Dart Aerospace Ltd

DART SERVICE INSTRUCTION

TO AMEND INSTALLATION INSTRUCTIONS D350-591 REV. G
AND INSTRUCTIONS FOR CONTINUED AIRWORTHINESS ICA-D350-591 REV. 3

TO PROVIDE AN OPTIONAL CUSHION KIT TO BE INSTALLED ON THE D350-591-111A/-113/-115/-117A/-119 *Heli-Access-Step*™ (THE D2856-400-720 ABRASION STRIP IS REPLACED WITH THE D3595-200-300 CUSHION).

FIGURE 32-9: Crosstube Attachment
REF ICA-D350-591

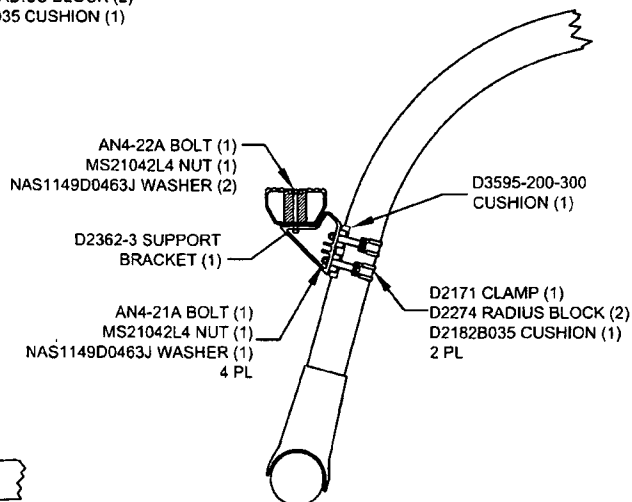
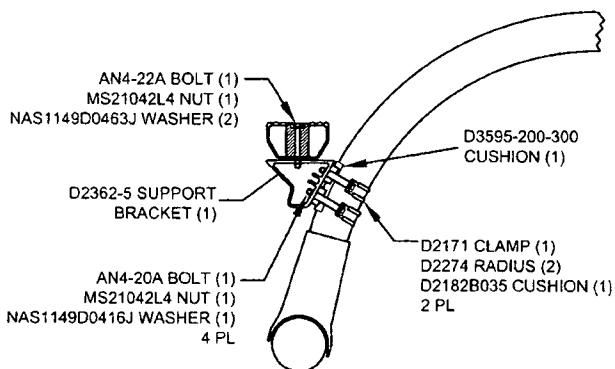
1. REMOVE THE STEP PER ICA-D350-591 SECTION 32.2
2. REMOVE THE D2856-400-720 ABRASION STRIP PER ICA-D350-591 SECTION 32.4
3. POSITION THE D3595-200-300 CUSHION AS INDICATED ON SHEET 3 OR 4 (AS APPLICABLE) OF THIS SERVICE INSTRUCTION.
4. REINSTALL THE STEP PER ICA-D350-591 SECTION 32.1 AS APPLICABLE USING THE NEW HARDWARE PROVIDED AS SHOWN ON SHEET 3 OR 4 (AS APPLICABLE) OF THIS SERVICE INSTRUCTION.
